**METROPOLITAN GOVERNMENT OF NASHVILLE AND DAVIDSON COUNTY**

**STAFF RECOMMENDATION**  
**3720 Central Avenue**  
**June 18, 2014**

**Application:** New construction—addition  
**District:** Richland-West End Neighborhood Conservation Zoning Overlay  
**Council District:** 24  
**Map and Parcel Number:** 10409002100  
**Applicant:** George Clements  
**Project Lead:** Melissa Baldock, [melissa.baldock@nashville.gov](mailto:melissa.baldock@nashville.gov)

<p><b>Description of Project:</b> Applicant proposes to alter the house’s porch roof slope and to add a pedimented vent to the porch roof to address water drainage issues.</p> <p><b>Recommendation Summary:</b> With the condition that staff approve the roof material and color, Staff recommends approval of the demolition of the deteriorated porch roof and the increase in the slope of the porch roof, finding that they meet Sections II.B.e and III.B.2. of the <i>Richland-West End Neighborhood Conservation Zoning Overlay: Handbook and Design Guidelines</i>.</p> <p>Staff recommends disapproval of addition of the pedimented vent, finding that it does not meet Sections II.B.2.a. of the <i>Richland-West End Neighborhood Conservation Zonin

**Proposed  
Porch Comparison**

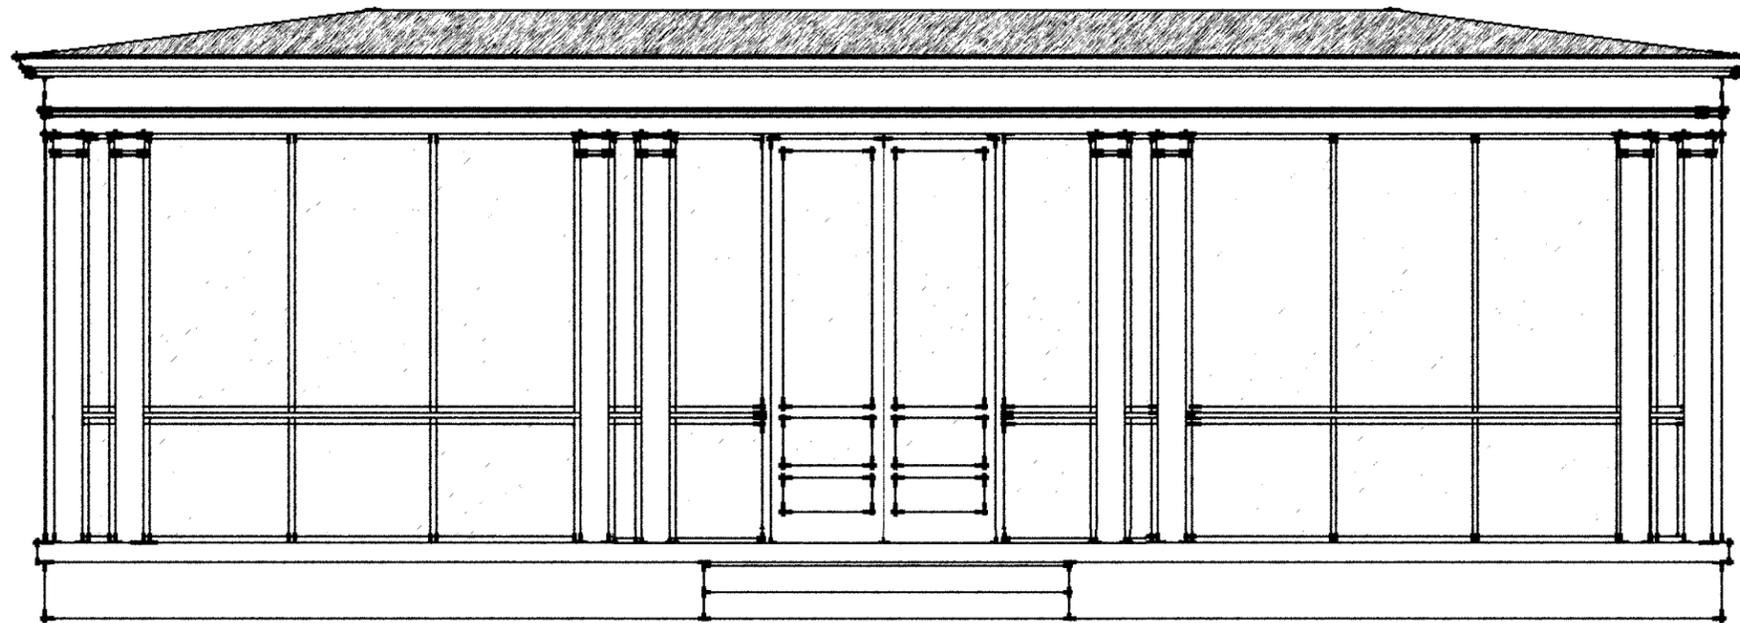
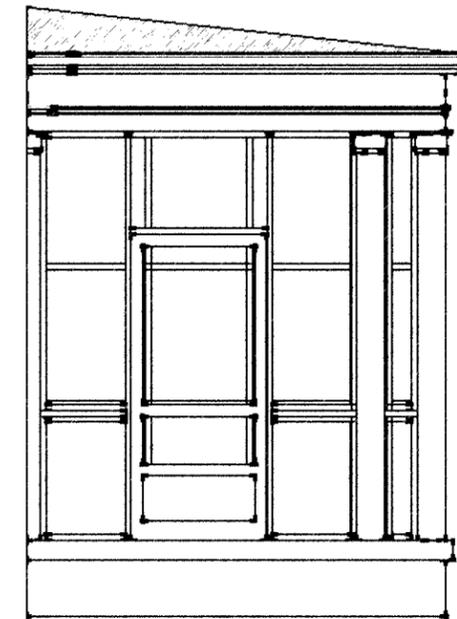
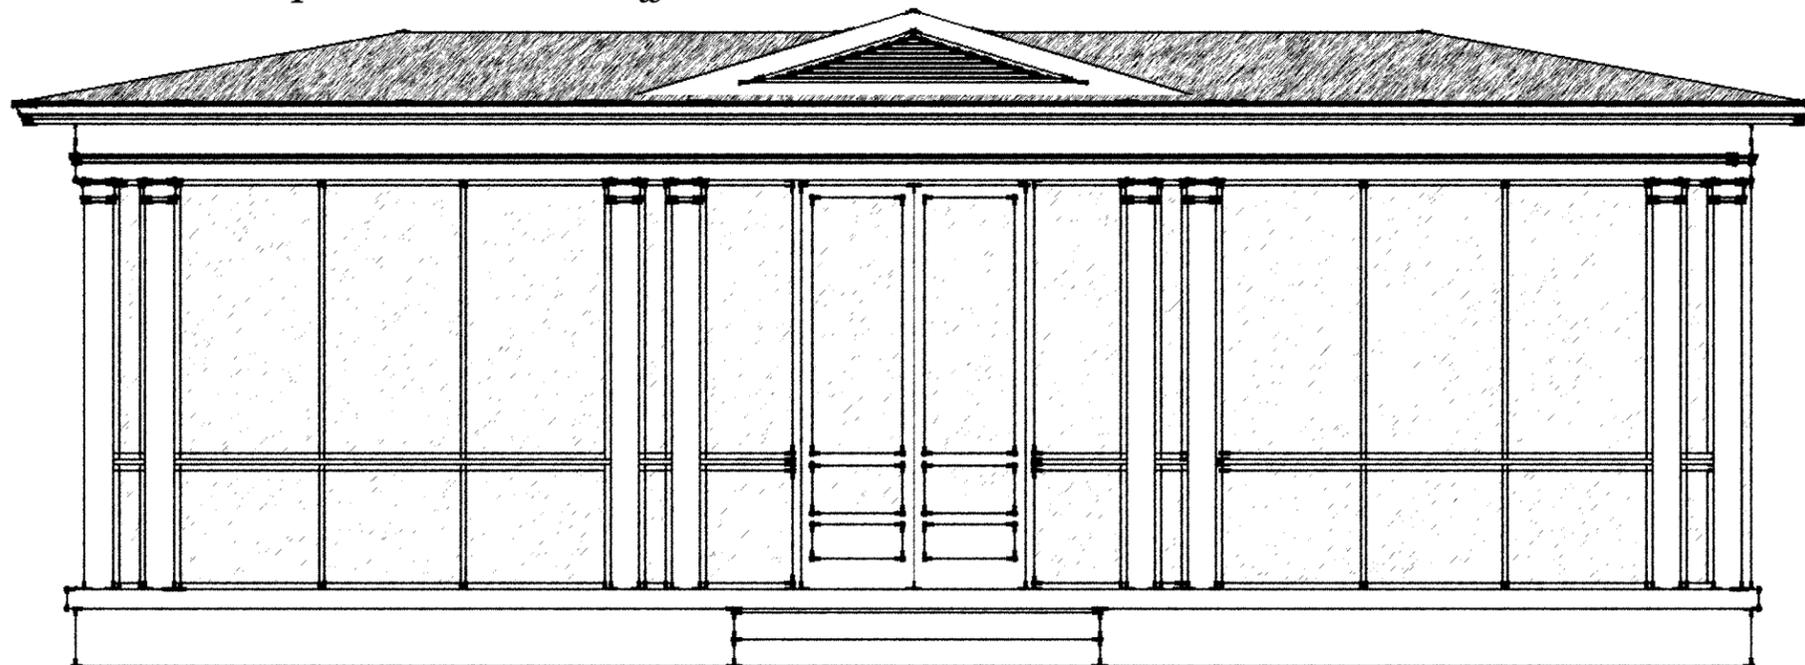
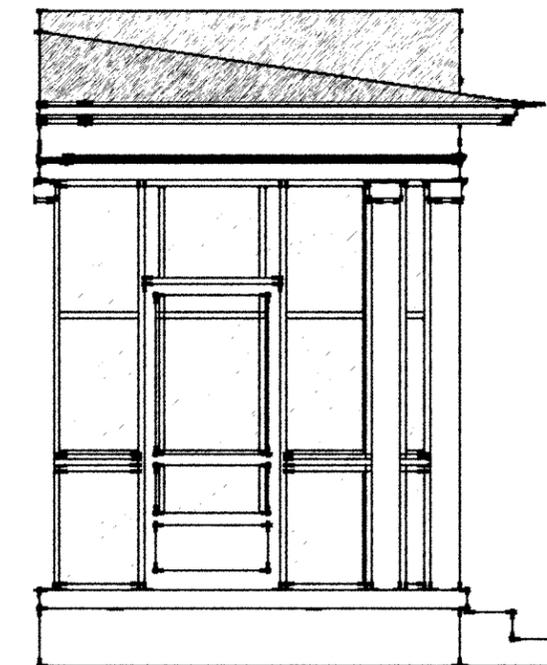
Roof Form, Location & Removability: The applicant is proposing to increase the slope of the porch roof slightly and add a pediment feature to the front of porch roof. The current porch has a roof slope of approximately 1.5/12, and the applicant is proposing to increase the slope slightly to approximately 2/12 in order to allow for better drainage on the roof. Staff finds that increasing the roof slope to 2/12 will not significantly affect the appearance of the roof and will not alter the significance of this contributing feature. Staff therefore finds that the alteration to the roof slope meets the design guidelines.

The applicant is also proposing to add to the front of the porch roof a pedimented vent to help with water evaporation. There is no evidence that this porch roof ever had a pedimented vent at the front, and the element would alter the historic look of the front porch, which is a significant architectural feature. The Secretary of the Interior's Standards for Treatment of Historic Properties, upon which the design guidelines are based, state that "alteration of features and spaces that characterize a property shall be avoided." In addition, they state that "Changes that create a false sense of historical development, such as adding conjectural features or architectural elements from other buildings, shall not be undertaken." This direction is evident in design guidelines section II.B.a and b for additions which states that generally additions should be where they are minimally visible. In this case, the porch is highly visible. In addition it states that contemporary designs are only appropriate when such additions do not destroy significant historical characteristics of the property. In this case, the proposal requires a redesign of the original porch configuration.

Because the pedimented vent it is not a common feature for porch roofs in the Richland-West End neighborhood, staff finds that it does not meet section II.B.1.e. of the design guidelines. Lastly, the Secretary of Interior's Standards state that "Replacement of missing features shall be substantiated by documentary, physical, or pictorial evidence." Since there is no evidence that the pedimented vent ever existed, staff finds that the feature does not meet the Secretary of the Interior's guidelines.

Staff notes that the ventilation of the porch roof could be accomplished with a combination of soffit vents and a roof to wall vent, which would not significantly impact the historic character of the porch or house.

**Recommendation Summary:** With the condition that staff approve the roof material and color, Staff recommends approval of the demolition of the deteriorated porch roof and the increase in the slope of the porch roof, finding that they meet Sections III.B.2. of the *Richland-West End Neighborhood Conservation Zoning Overlay: Handbook and Design Guidelines*.

Staff recommends disapproval of addition of the pedimented vent, finding that it does not meet Sections II.B.1.e and II.B.2.a. of the *Richland-West End Neighborhood Conservation Zoning Overlay: Handbook and Design Guidelines*.
